UNITED STATES PATENT AND TRADEMARK OFFICE

10/789,365

Office Action Summary	Application No. 10/789,365	Applicant(s) DENOTH ET AL.	
	Examiner QUYNH-NHU H. VU	Art Unit 3763

DETAILED ACTION

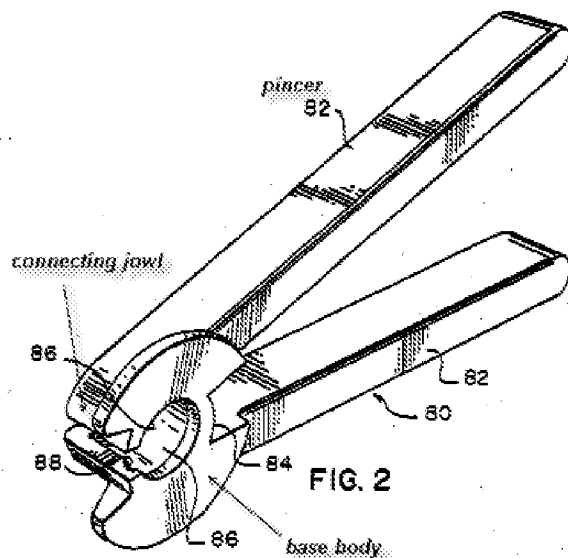
Regarding claims 1-18, Lee et al. disclose a port system comprising: a replaceable implantable first fluid guiding system 30 (col. 4, lines 37-43; an external second fluid guiding system 66, a connecting device 100 and 92 which comprises a second connecting elements 102 or 92; wherein the connecting head is fastened to the port casing 12.

Regarding claims 19-27, Lee et al. discloses a connecting device comprises a pair of pincers 82 carried on a connecting head 92 (where the stabilizing tool 80 is locked or attached to device 10) of fluid guiding system and further comprises a base body, and a connecting cannula 42 and at least one connecting jaw which can be splayed from said base body against a restoring elasticity force (see Fig. 2 below for more details).

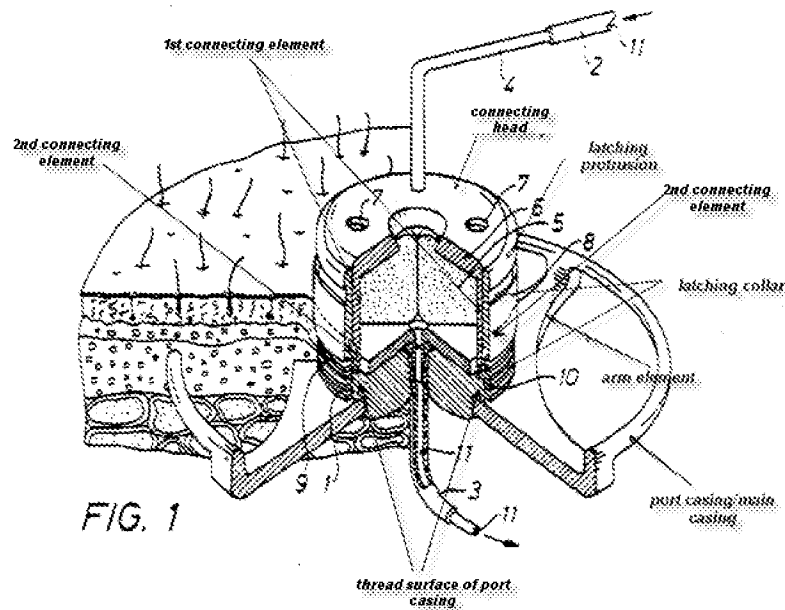
Claims 28-31 are rejected under 35 U.S.C. 102(b) as being anticipated by Svensson et al. (US 5,098,397).

Svensson discloses, (in Figs. 1-2, also see Fig. below for more details), a port system comprising: an implantable first fluid guiding system 3 or 11; an external second fluid guiding system 2 or 4 with a connecting head 6, 8 at one end; a percutaneously implantable port for establishing a fluid connection between said fluid guiding systems, said port comprising a port casing 10 having a threaded surface (engaged at location 1); and a connecting device (include 5, 6 and 8) comprising a thread surface (6 or 8, col. 2, lines 1-20) which engage with the port casing thread surface; a plurality of comprises a second connecting element 8; and wherein said connecting head is fastened to said port casing 10 by a releasable fastening engagement (at zone 9) of said connecting element.

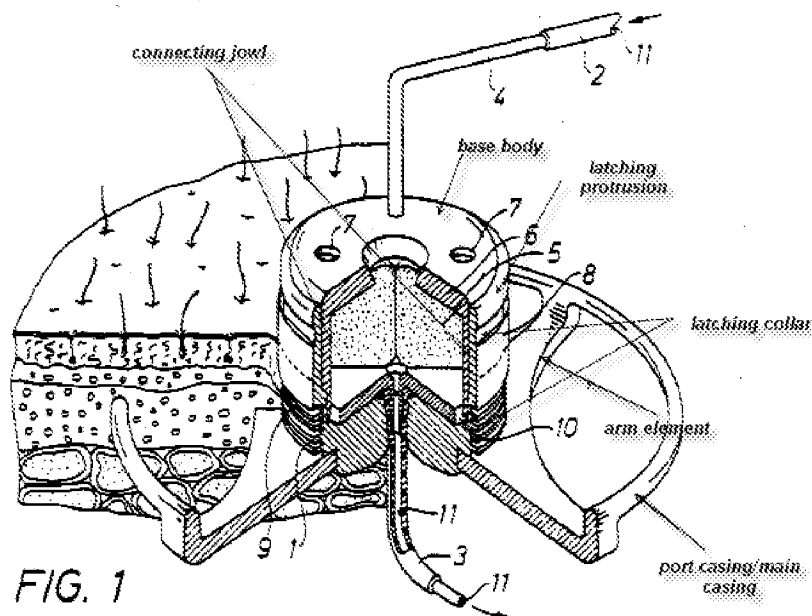
Regarding claims 5-6, one of the connecting elements forms a latching protrusion (at zone 9) comprising the latching collar.

Regarding claim 7, the connecting head comprises a connecting cannula which in the fastening engagement of the connecting elements protrudes into the port casing and is freed from or at least relieved of external force by the fastening engagement.

Regarding claims 8-9, (see Fig. 1 below) the connecting head comprises a base body 6 (a disc-shaped part) and a connecting jowl (the leg part vertically and directly contact with outer cylinder 8) forms the second connecting element.

Regarding claims 12-14, (see Fig. 1 below for more details), latching protrusion and latching collar encircle said longitudinal axis of the port casing in curved arc segments; a plurality of arm elements.
